DEVIATION REVIEW AND DECISION FORM

Subdivision or Project Name: Stonebridge Filing 4 at Meridian Ranch

Section of ECM from which Deviation Is Sought: 2.3.8.A Cul-de-sacs (maximum allowed grade, Fig 2-31)

MERIDIAN HILLS TR.
CUL-DE-SAC
(ALL GRADES ARE TBC)

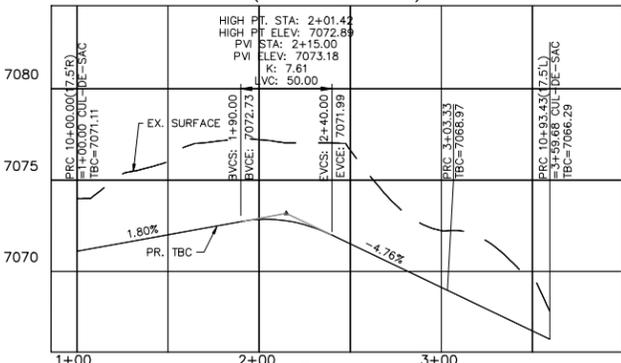
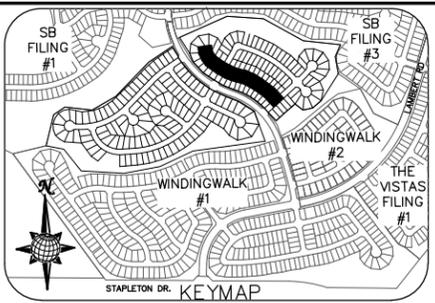
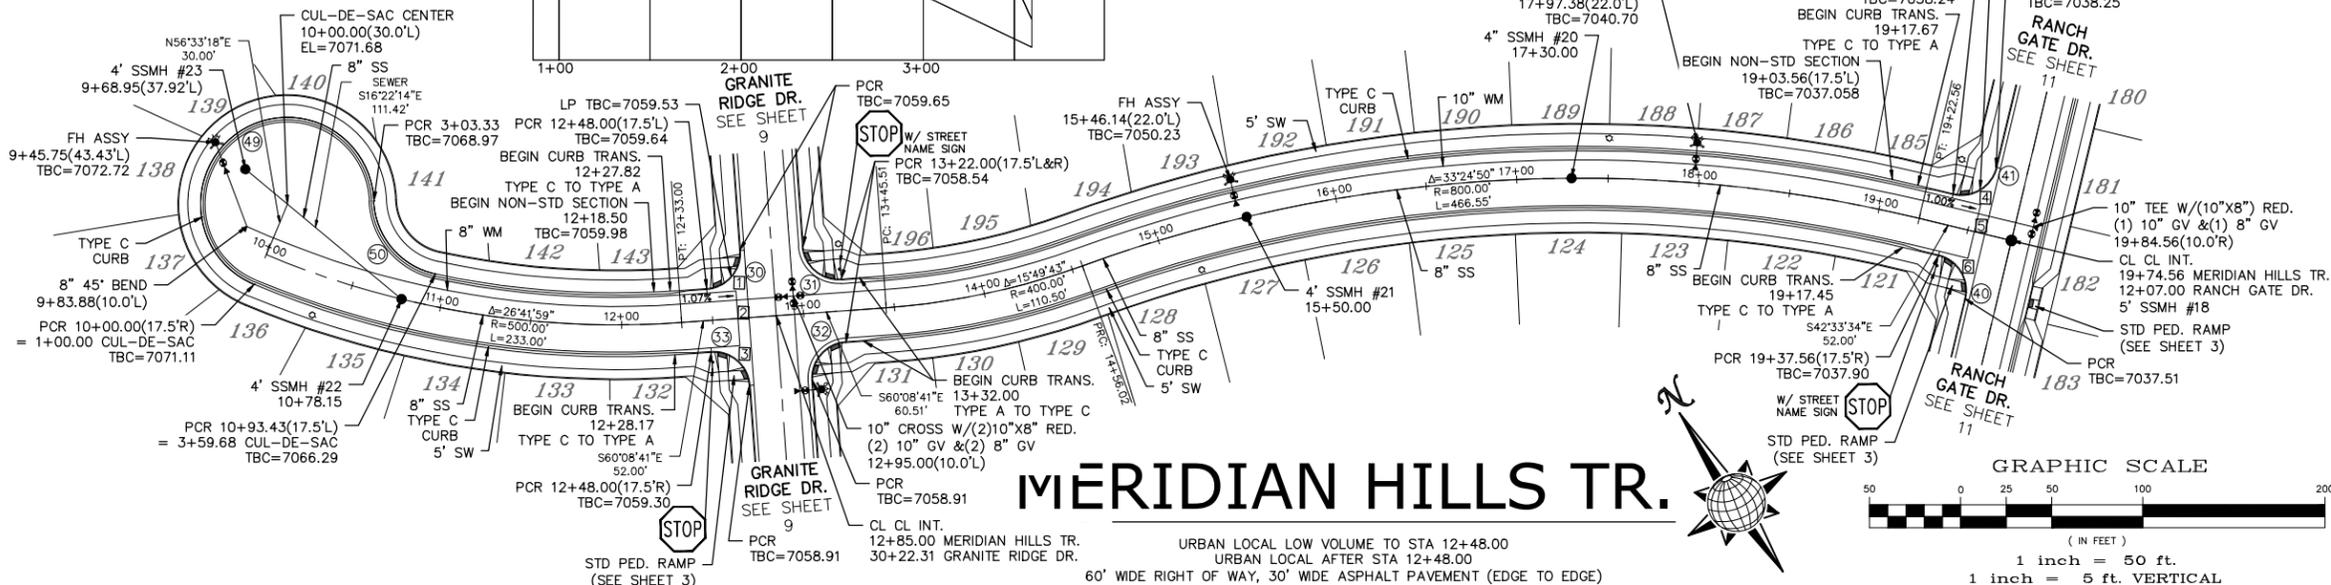
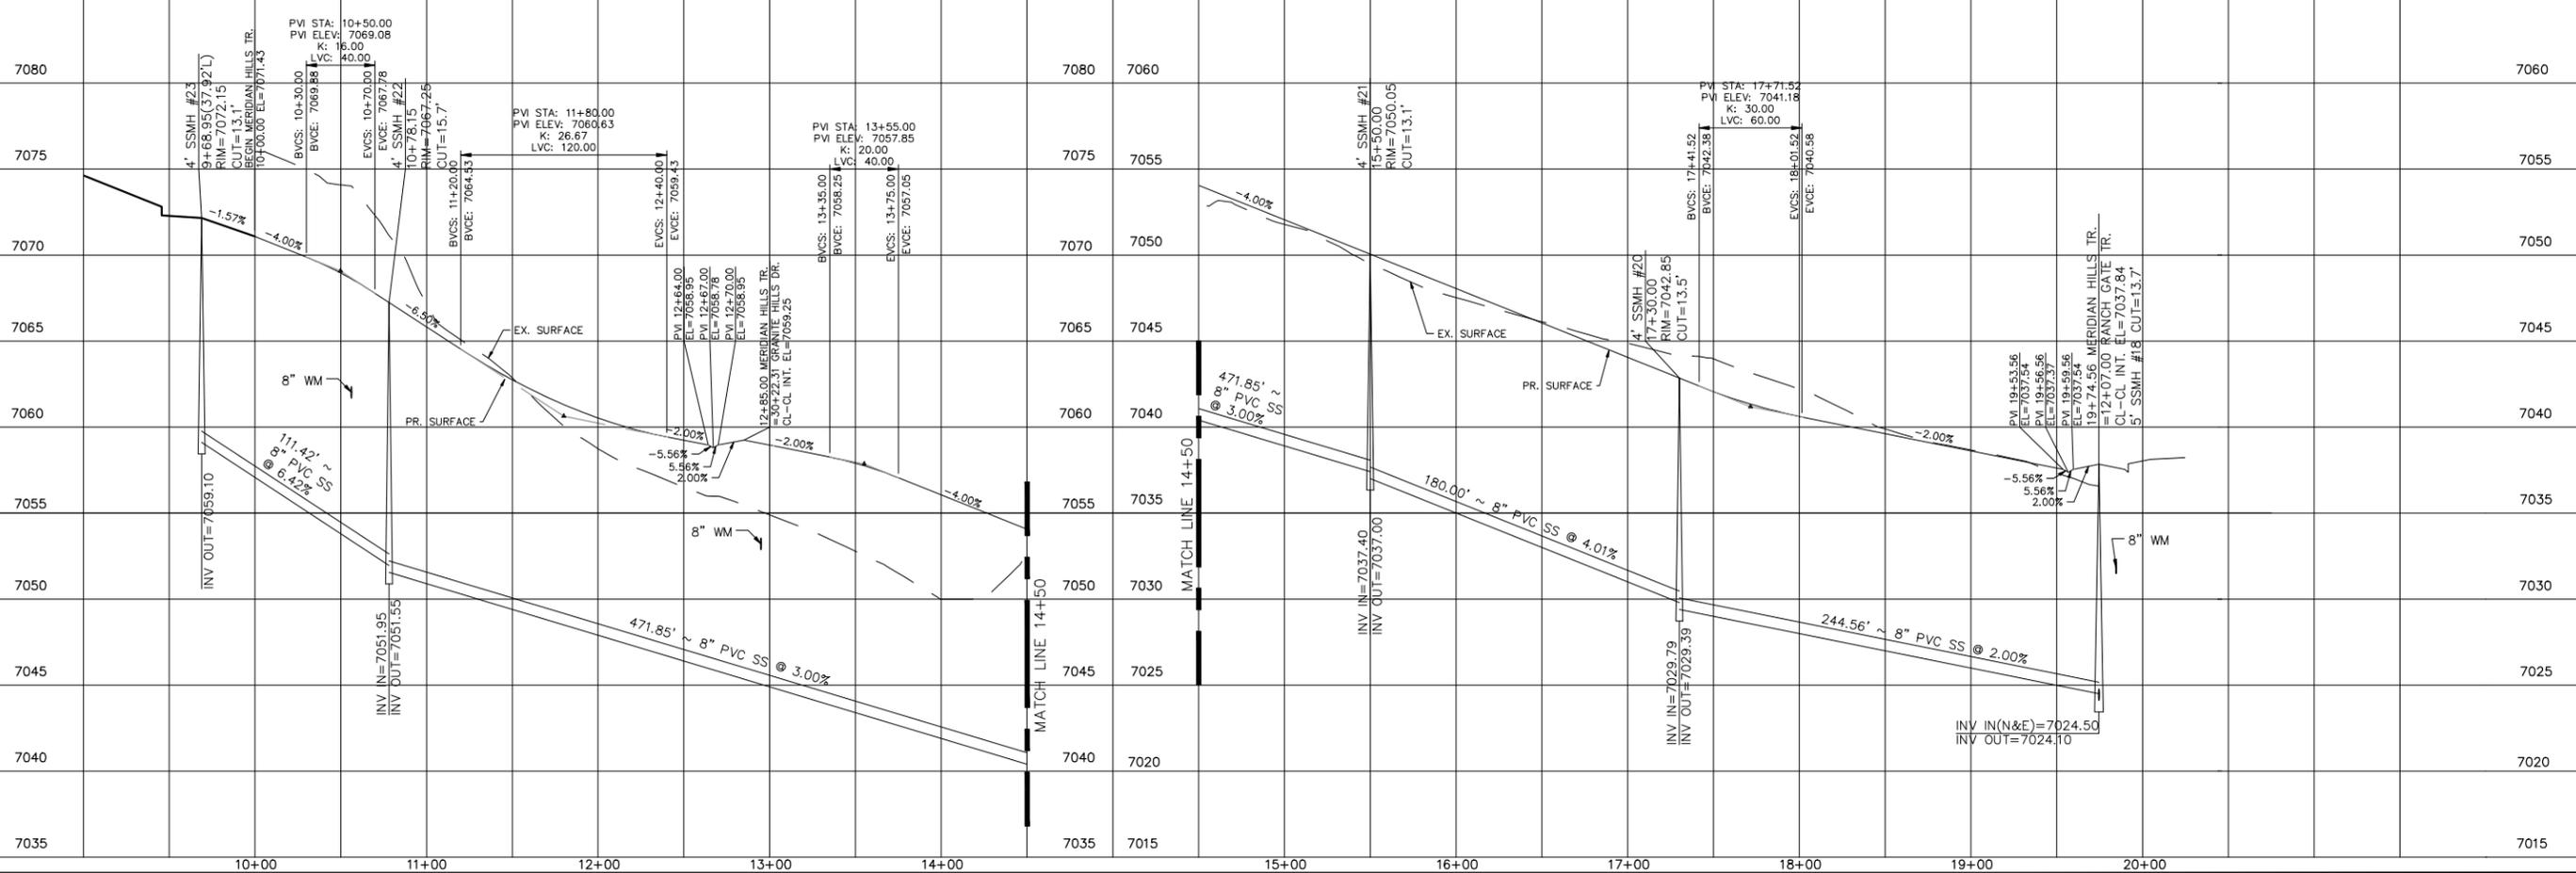
Proposed Nature and Extent of Deviation: The request for a deviation is to allow the proposed centerline grade to exceed 3% to a grade of 4% through the cul-de-sac bulb.

Proposed Nature and Extent of Deviation: The request for a deviation is to allow the proposed centerline grade to exceed 3% to a grade of 4% within the cul-de-sac bulb of Meridian Hills Dr, a cul-de-sac located north of Granite Hills Dr and east of Rainbow Bridge Dr.

Reason for the Requested Deviation: The project is located between Stone Valley Dr and Granite Hills Dr where the existing grade differential is approximately 22 feet. Stonebridge Filing 3 is located to the north with an open space located between the two sets of lots; there is a drainage swale that captures and directs runoff easterly along the open space toward a point where the runoff can be captured and directed to Gieck Detention Pond E. The design limitations associated with the vertical and horizontal constraints applied to Rainbow Bridge Dr further complicated the lot layout and street alignments in the area. The street length to the cul-de-sac bulb is relatively short; 285 feet measured along the centerline from the radius point to the centerline intersection with Granite Hills Dr. If the guidelines and criteria were strictly followed to limit the grade through the cul-de-sac bulb at 3.0%; retaining walls may need to be constructed along the rear property lines of the lots on the cul-de-sac in order to preserve the established major drainage basin boundaries and those areas draining to two regional detention ponds, Or the centerline grade of the street may need to be around 8% or greater and minimum vertical curve lengths would be difficult to meet creating sight line difficulties.

Comparison of Proposed Deviation to ECM Standard: The request is to waive the 3% maximum grade within the cul-de-sac bulb and approaching throat and allow a maximum grade of 4% through most of the cul-de-sac bulb and transition to the centerline grade of roughly 6.5% by means of a vertical curve through the approaching throat.

The proposed deviation does not limited sight distance. The K-value for Stopping Sight Distances on a Crest Vertical Curve is calculated at 7.6 as measured for a vehicle traveling along the curb. This provides sufficient stopping distance for a vehicle traveling in excess of 25 mph.

This request has been determined to have met the criteria for approval. A deviation from Section 2.3.8 of ECM is hereby granted based on the justification provided. Comments:
